DEPARTMENT OF PLANNING AND DEVELOPMENT  
**CIVIC DESIGN REVIEW**  
CITY OF PHILADELPHIA

**4401 RIDGE AVENUE**  
PHILADELPHIA, PA 19129

LANDSCAPE SITE PLAN RENDER  
Sheet 1 of 2

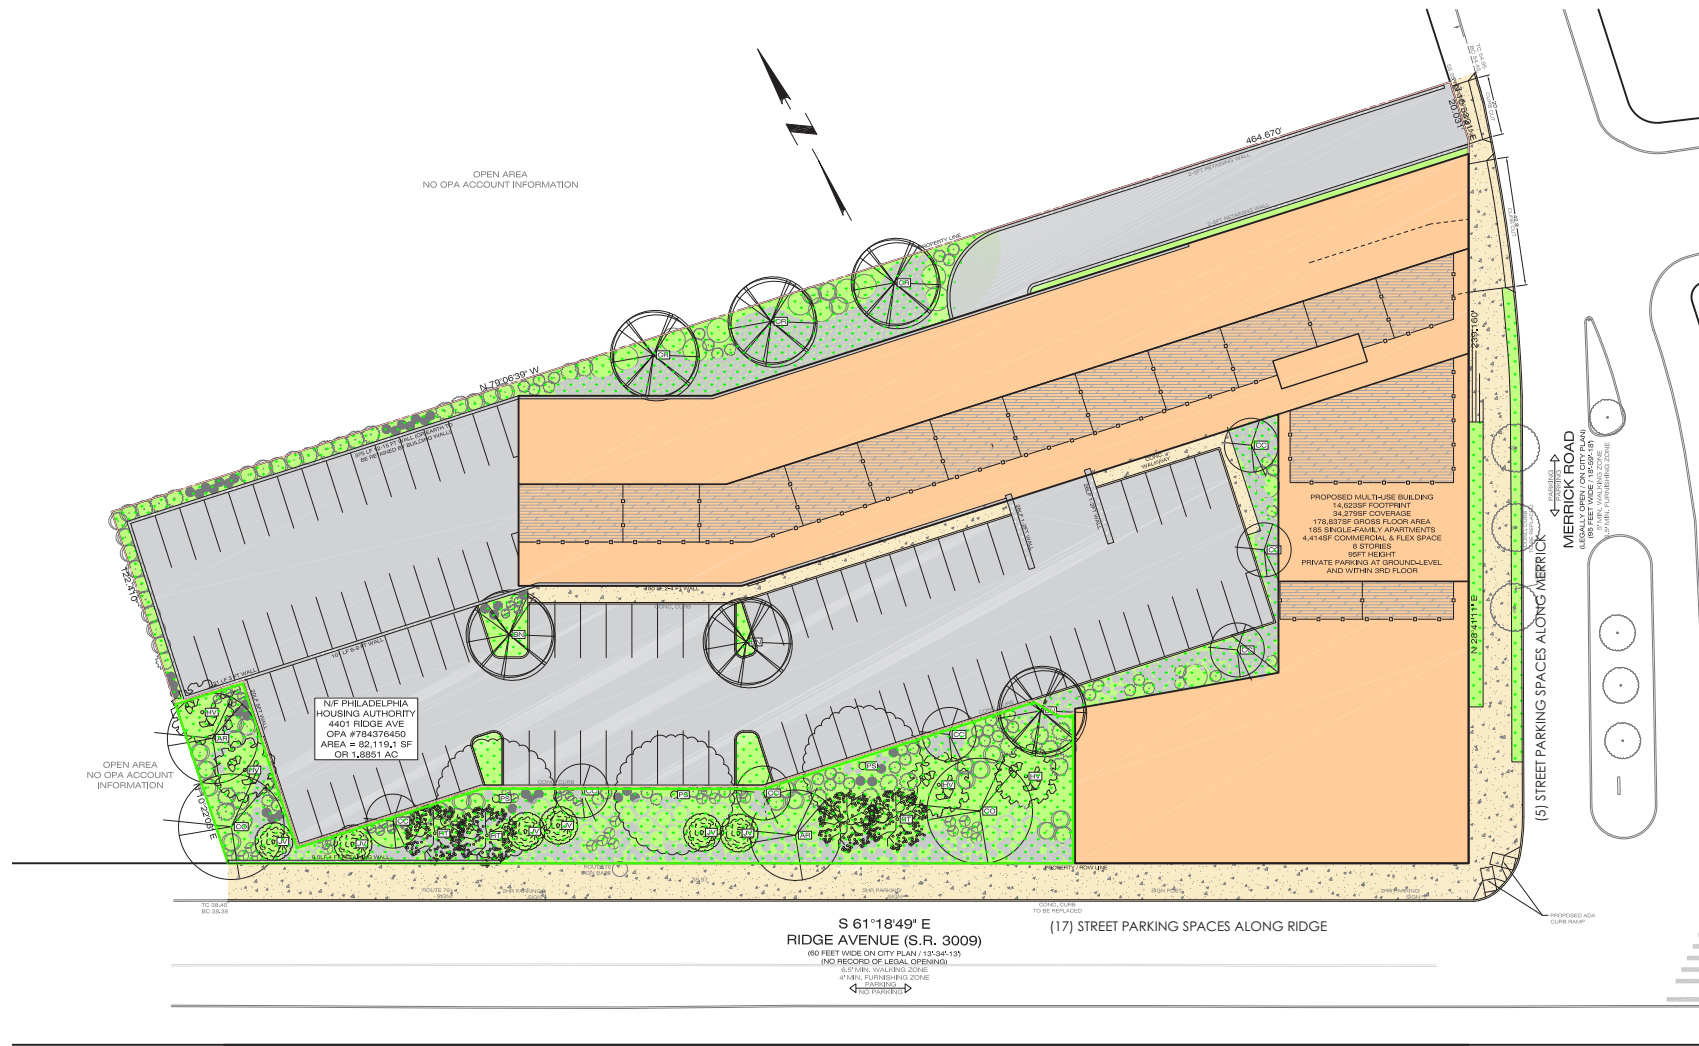
<p><b>1f</b></p>	<p>The RCO wants to see more sustainable design features</p> <p>RESPONSE: We are considering additional green roof and we are planning to add a permeable surface to a portion of the surface parking area.</p>

<b>1d</b>	Parking areas could be better connected to the streets via the green space along Ridge, and, consider making more connections to the green space from the dwelling units. RESPONSE: <b>The parking on site will be for the exclusive use of our residents. We believe there are limited use cases for the residents to utilize this connection. Alternatively, we believe that this direct connection will create a security hazard in the private parking area. Alternatively, we are investigating the inclusion of a public pocket park in the landscaped area along Ridge Ave that will be accessible to the whole community.</b>
<b>1e</b>	Consider more exploration of stormwater solutions RESPONSE: <b>We are considering additional green roof and we are planning to add a permeable surface to a portion of the surface parking area.</b>
<b>1f</b>	Concern that units in the large back of the building front on the hill, and the committee wants to know why that decision was made RESPONSE: <b>Positioning of the building on the site was discussed in RCO Comments 1c above. We feel the current design connects the building to Ridge Ave with over 100' of frontage, connects it to the Schuylkill River and Center City with unobstructed view and sight lines, avoids overshadowing Ridge Ave, and enhances the street front with a well landscaped green edge facing the community.</b>

# RIDGE AVENUE (SOUTH) ELEVATION

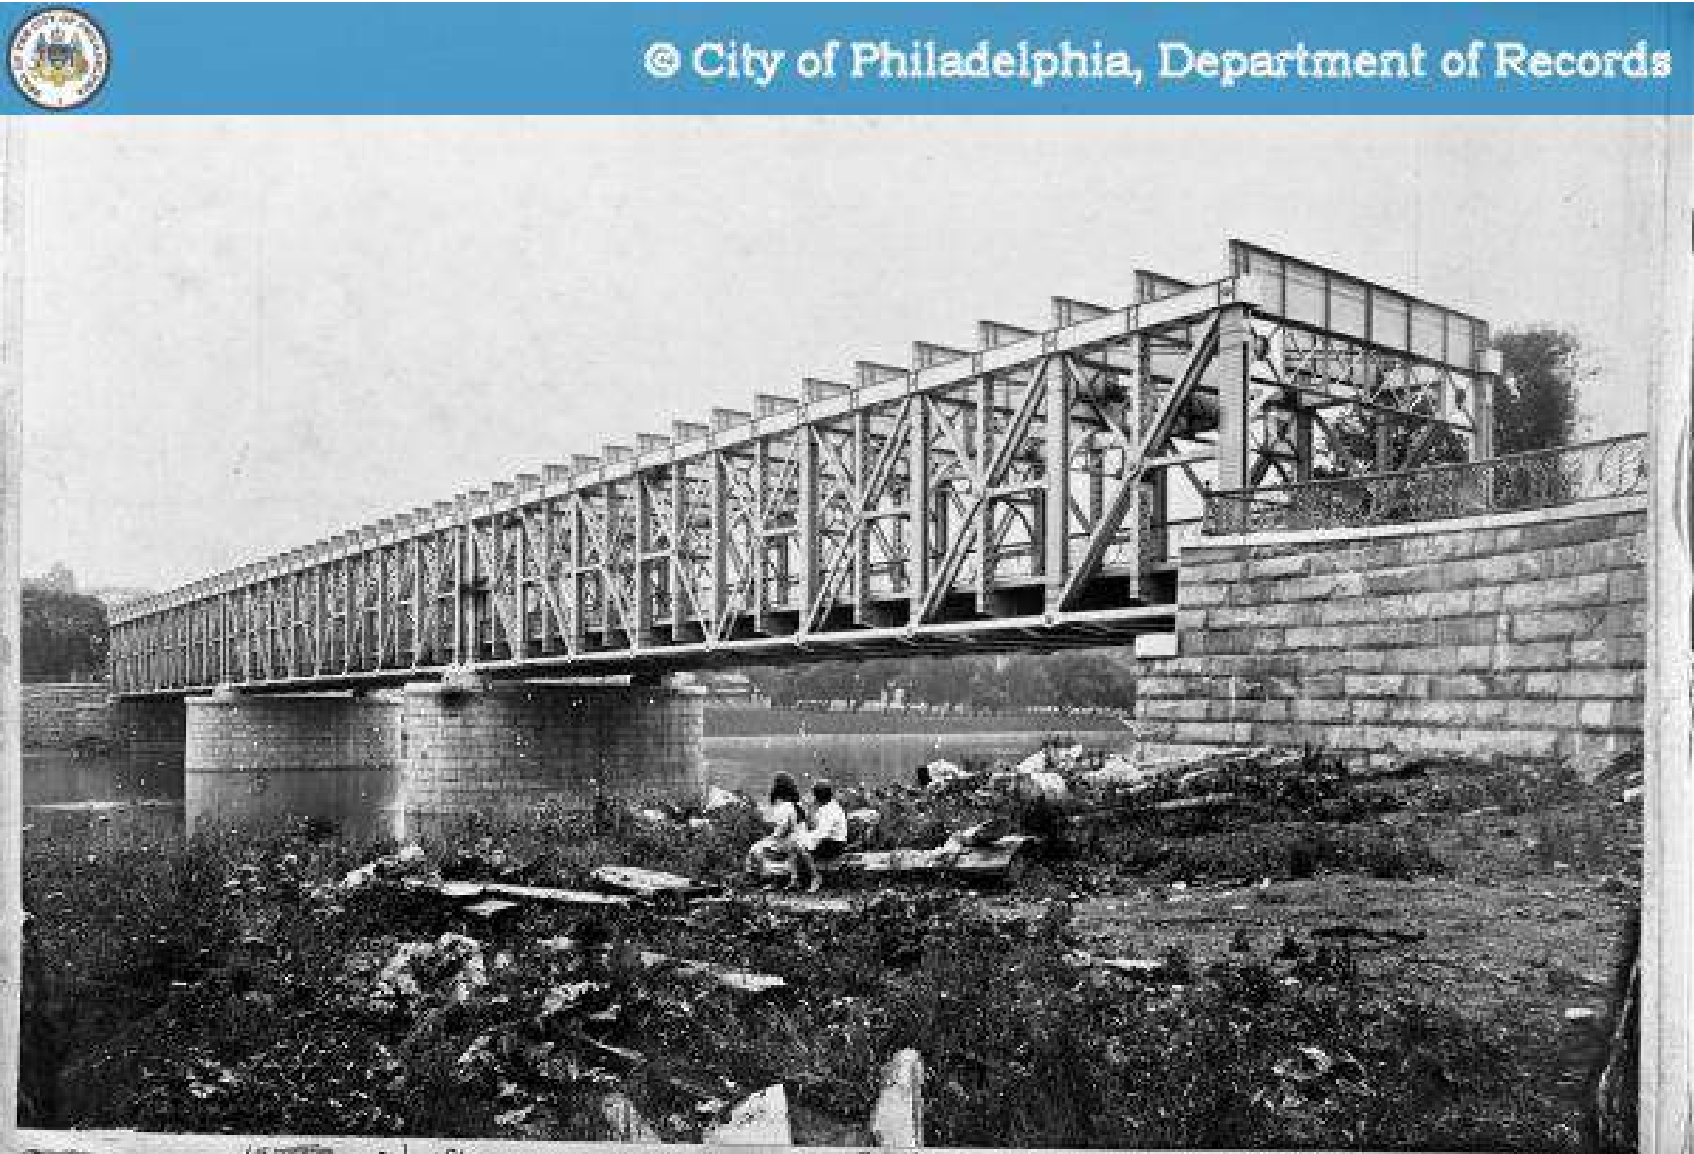
1c	<p>Layout does not engage Ridge Ave and will not do enough to revitalize it. The building is too far from Ridge and there are not enough eyes on the streets. The RCO wants building brought to Ridge Ave and away from adjacent houses. It should make a better connection to 4442 Ridge Avenue site</p> <p>RESPONSE: The building as proposed has a meaningful presence on Ridge Ave at the corner of Ridge Ave and Merrick St. The proposed retail presence at the corner with the purposely designed connected exterior sidewalk area will generate street activity that has not existed at this section of Ridge in many years. The positioning of the building takes advantage of the natural sloping of the site, embraces the connectivity to the River by placing it over the buildings on Kelly Drive allowing for views of the Schuylkill (a point that the RCO has mentioned several times), significantly enhances the views toward Center City and the city skyline, and eliminates the canyon effect that would occur along Ridge with a 6 - 7 story building fronting directly on the street.</p>

<p><b>1g</b></p>	<p>Clarifies that additional building frontage along Ridge does not need to be retail. It could be uses other than parking, such as residential, that could contribute and plug the gaps along the street</p> <p>RESPONSE: Current zoning overlay requires that 50% of the ground floor Ridge Ave frontage be programmed for retail use. Adding strictly residential uses along Ridge would require a use variance.</p>
<p><b>1h</b></p>	<p>The RCO likes the building design but it does not belong in this context. It is more suitable for the Navy Yard</p> <p>RESPONSE: We believe the building design fits well at this location. While it is a more contemporary design than some nearby dwelling units, it is well within the context of the area and pays homage to the history of the neighborhood and structures such as the Falls Bridge (the most prominent architectural feature in the neighborhood).</p>
